Access Compliance Report Public Rights-of-Way (Curb Ramps)

Main Street: CRESTKNOLL_DR **Cross Street:** LARKRIDGE_DR **Location:** SE

ADA ID: RPAT210923094114 **Ramp Type:** Type 3 - Combination 1 **Initial Pass/Fail:** Fail **Overall Compliance:** No **Severity Score:** 16

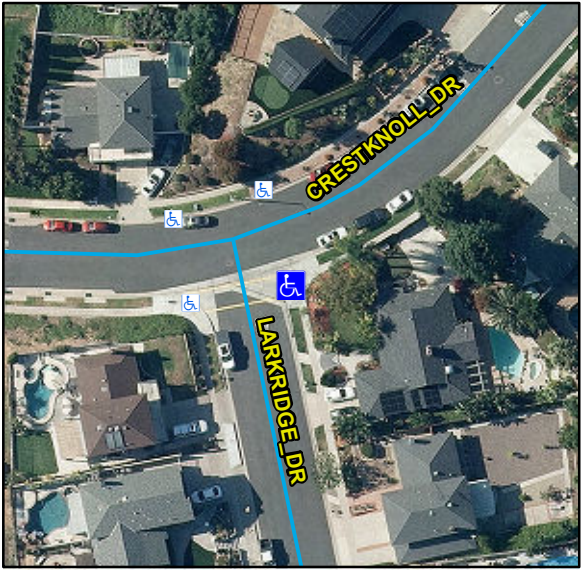
OC Std/PROW:
 R304.2.2, R304.5.3, R304.3.2, STD 1115

Compliance	Description	Data	Compliance	Description	Data
N/A	Ramp Length LT (in)	88	N/A	Ramp Length RT (in)	75
Yes	Ramp Width LT (in)	48	Yes	Ramp Width RT (in)	50
No	Ramp Run Slope LT (%)	11.9	No	Ramp Run Slope RT (%)	8.7
No	Ramp Cross Slope LT (%)	3.3	Yes	Ramp Cross Slope RT (%)	0.9
N/A	Ramp Length (in)	46	N/A	Flare Type LT	
Yes	Ramp Width (in)	48			N/A
No	Ramp Run Slope (%)	8.6	N/A	Flare Slope LT (%)	N/A
No	Ramp Cross Slope (%)	2.4	N/A	Flare Traversable LT	N/A
N/A	Landing Present	N/A	N/A	Flare Type RT	
N/A	Landing Length (in)	N/A			N/A
N/A	Landing Width (in)	N/A	N/A	Flare Slope RT (%)	N/A
N/A	Landing Run Slope (%)	N/A	N/A	Flare Traversable RT	N/A
N/A	Landing Cross Slope (%)	N/A	N/A	DWS Provided	N/A
N/A	Landing Movement Obstructed?	N/A	N/A	DWS Contrast	N/A
	Landing Movement Type	N/A	N/A	DWS Length (in)	N/A
N/A	Landing Shared	N/A	N/A	DWS Full Width	N/A
N/A	Clear Space	Yes		DWS Offset Type	N/A
N/A	Clear Space To Crosswalk (in)	N/A	N/A	DWS Offset Left (in)	N/A

Possible Solutions:
Remove & Replace Curb Ramp With Two New Directional Ramps or Equivalent.
